### **Air Studios**

### **Structural and Ground Dynamics**

Revised Planning Submission – CED Response Note

**Ref:** AKS/3400/Revised Planning Submission– CED Response Note (18/07/16)

Fig 6.1

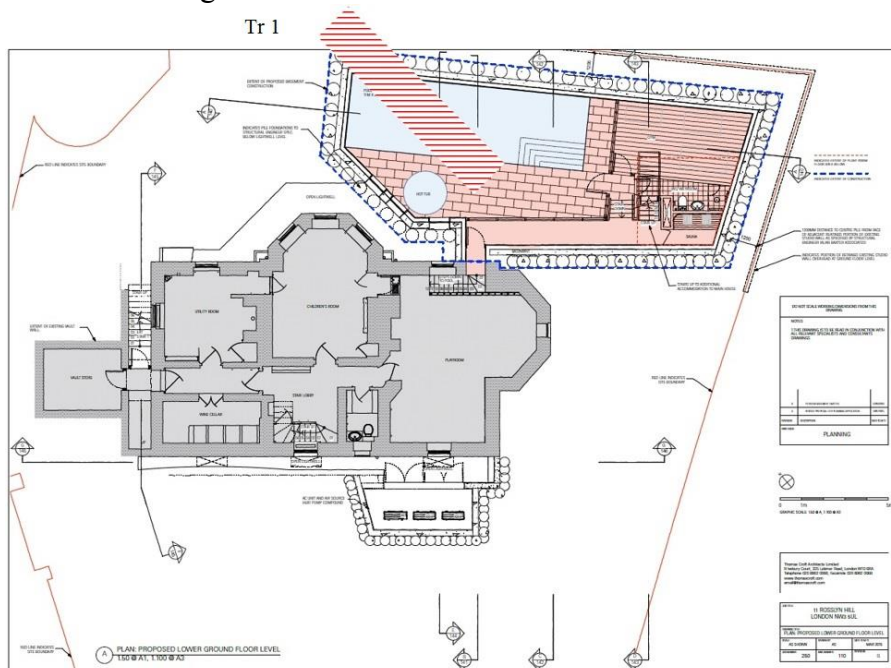
6.1. Fig 6.1 highlights the Archaeological Trench (1) that was previously dug during December 2015, superimposed on the planned revised basement scheme. At closest proximity, the archaeological trench (Tr1) and the proposed deep basement are within about 7m of the Air Studios building.

6.2. It is significant to note that the Applicants’ representative in planning the works for the Archaeological Trial Pits (Trench 2 not shown) confirmed to seek to undertake the noisiest works between the hours of 8am and 10am on the days the studios were in use, having been informed that recording that particular week on the days of studio use would begin after 11am. It was therefore surprising to see the pecker, an obvious noisy activity, being used without regard to that arrangement, and persisting in use through the middle of that day during which studios were timetabled for use. Such breaches of a voluntary arrangement would understandably undermine confidence in any future arrangements. Such experience shows that harm to amenity is almost guaranteed to take place, despite any prior arrangements given with the best of intentions or for expediency. There is therefore a net impact, which will not be eliminated and the evidence of arrangements failing on the small minor works here are a reasonable indicator to the future. Furthermore, CED reported measurement samples which show that even minor works (trench 1 within 7m of Air Studios) are very intrusive and incompatible for recording studio use, causing harm to amenity.
